Eighty-fifth session
Geneva, 26-29 October 2021
Item 4 (c) of the provisional agenda
Simplification of lighting and light-signalling UN Regulations:
UN Regulation No. 149 (Road illumination devices)

## Proposal for amendments to UN Regulation No. 149

Submitted by the Informal Working Group on Simplification of Lighting and Light-Signalling Regulations (IWG SLR)\*

"Figure A4-V

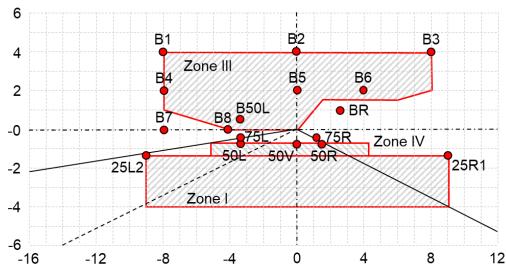
Figure A4-V, amend to read:

- 1. In paragraphs 3.3.2.4. and 3.3.2.4.4. the proposal intends to clarify the existing provisions.
- 2. The provisions in paragraph 3.3.2.4.8. are contained in UN Regulation No. 123 (paragraph 4.2.2.3.) but are currently missing in UN Regulation No. 149.
- 3. The proposal corrects a wrong reference in paragraph 4.5.2.6. The correct reference is item 9.3.3. (a) in Annex 1, not item 9.3.2.3.
- 4. The proposal also corrects the locations of points 50L and 75L in Figures A4-V and A4-VII.

"Figure A4-VII

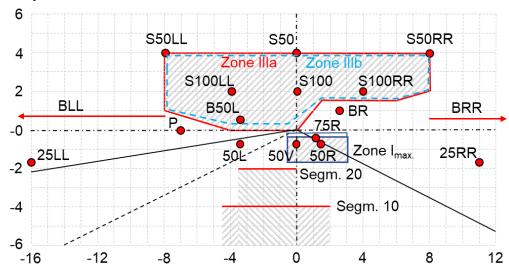
Figure A4-VII, amend to reads:
